ASSESSMENT OF COMPLIANCE TABLE WITH SEPP 64 ADVERTISING AND SIGNAGE

JRPP-15-02700 - Assessment of a Residential Care Facility (RCF)

Proposed Lot 2 in Nos. 37-43 Kildare Road, Blacktown

Roof sign on northern elevation visible from rail corridor

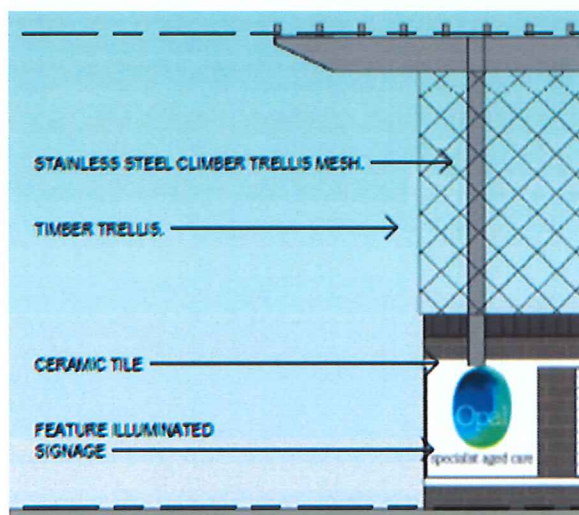
The roof sign (4.938m x 1.651m) has the Opal logo within a rectangular panel 1.3m high x 1m wide, with the words "Opal Specialist Aged Care". The roof sign will be visible from the railway corridor and to some extent from the open space area to the north, e.g. Blacktown Showground particularly if it is illuminated at night. The sign which measures 4.938m x 1.651m is located on one side of the lift/stair overrun, on the northern elevation of the building facing the rail corridor. It is inner illuminated.

This roof sign is not supported, given its prominent aspect and location in a residential area. Council would instead, consider a flush wall sign on the railway side of the rear boundary fence for business identification purposes.

The building's length is approximately 86m on its northern elevation. This sign is not compatible with the desired future residential character of the area.

We would suggest as an alternative that the applicant consider a flush wall sign on the railway side of the rear boundary fence for business identification purposes to assist visitors and clients to locate the building from the rail corridor, and the northern area of Blacktown CBD.
